RE: Marco Polo Comments Responses - 101 W 33Rd St - Bryan, TX

13. Sheets S0.2 and S0.3

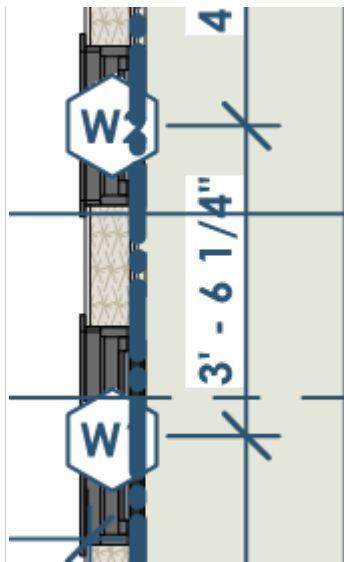
a. There's a callout for Detail / Section 6A on Sheet A500 but there isn't a detail 6A on that sheet. Corrected

17. Sheet A301

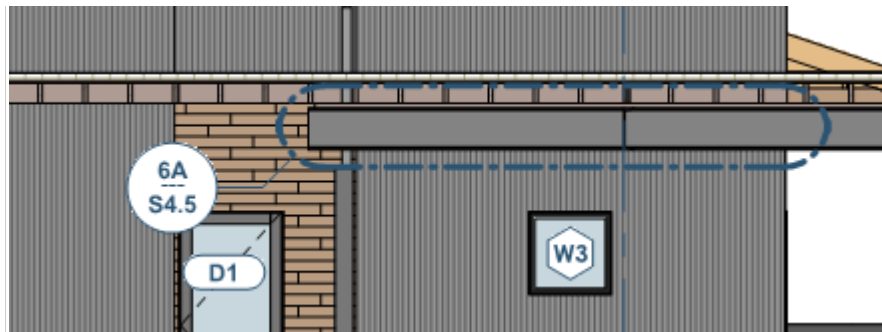
- a. You might consider moving these callouts because in the black and white sheets, they're getting lost in the exterior materials. **Corrected**

19. Sheet A410

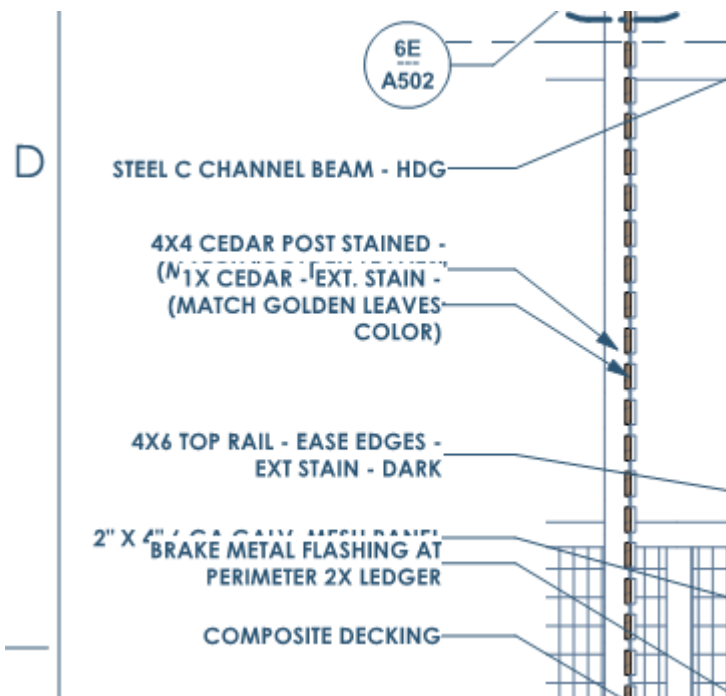
c. Please clean up this text – Corrected
